# Stormwater RFI Responses - Rocklea Lines Training Facility

**To** Ray Carey  
**From** Kripa Paudel  
**Date** 31 March 2026  
**RE Facility** Brisbane City Council RFI re. Development Application for Powerlink Rocklea Lines Training Facility

Figure 1: LCMITF project site location, showing the proposed land disturbance area (red hatched) and lot boundaries (red dashed). Reproduced from the original source: Aurecon, 2025.

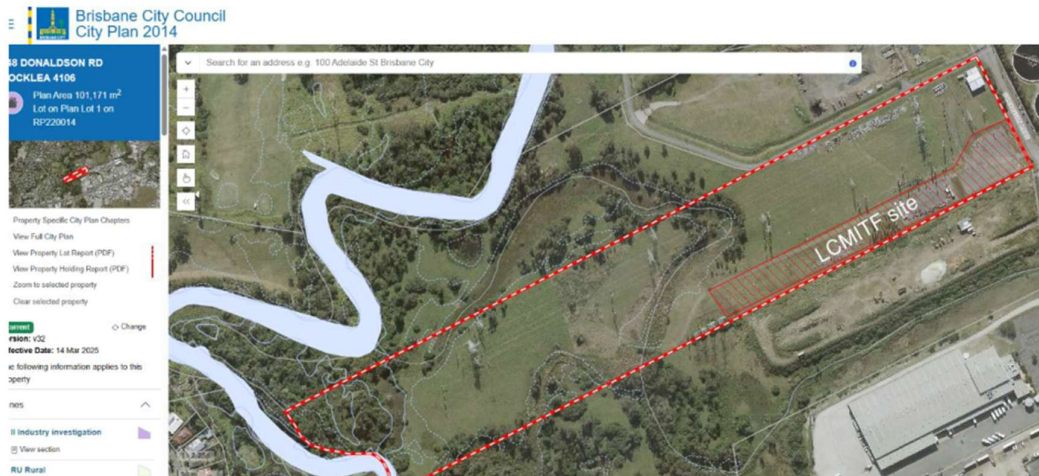
The lot area of the proposed development at 148 Donaldson Road, Rocklea is approximately 101,171m<sup>2</sup>. A 2025 report (Aurecon, 2025) addressing section 81 (s81) changes showed that the total land disturbance area associated with the works to be 14,000m<sup>2</sup>.

Figure 2: Impervious areas. Reproduced from the original source: Aurecon, 2025.

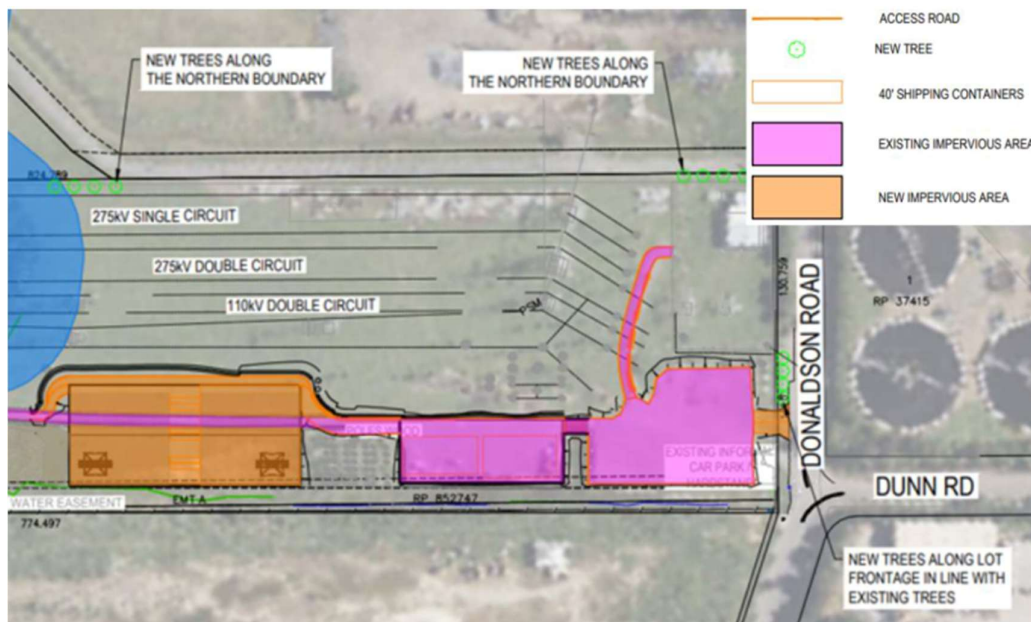
that application included “Earthworks (cut and fill) associated with providing a building pad and car park for the future second training facility”. S82 change only involves sealing of the existing gravel carpark (central pad in pink as per Figure 2). It was determined that this carpark is impervious in existing situation and agreed with Council so there is no change to impervious area between previous application and s82.
